From: Jason Adler
Sent: Monday, October 3, 2022 2:04 PM
To: Jesse J Stephenson
Cc: Cody Grathwold; sju@keytonola.com; James Uschold; Chase Klugh; Paul Cassano; andrew harris
Subject: RE: Laurel St (2353-2363) Roofing Scope Beinert

From: [Jason Adler](#)
Sent: Friday, September 30, 2022 2:17 PM
To: [Jesse J Stephenson](#)
Cc: [Cody Grathwold](#); sju@keytonola.com; [James Uschold](#)
Subject: Laurel St (2353-2363) Roofing Scope Beinert

Ridge tiles in New Orleans are often in an English-V profile with mortar between adjoining tiles as seen in the top drawing or in overlapping Spanish tiles as seen below.

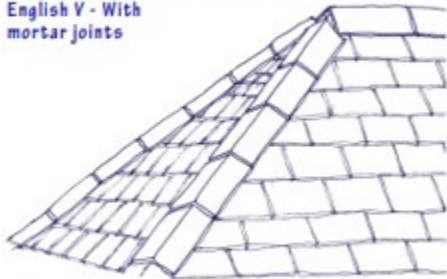
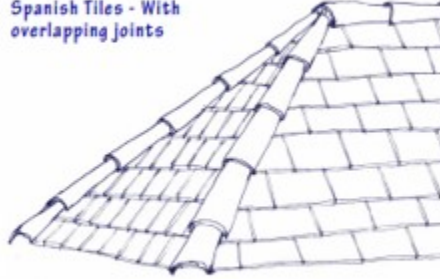
Thank you for sending these over. Currently the buildings have historic slate ridge tiles. The scopes note "R & R Ridge cap – composition shingles". At the staff level we can not approve that change. However, we can approve the removal and reuse of the existing slate ridge tiles.

If you do not wish to keep the ridge caps the HDLC commission will have to decide and I will reassign this to Chase Klugh.

Understood and sorry for the confusion. Yes, we will remove and re-use the existing historic slate ridge tiles. That has always been the plan, but I understand the confusion.
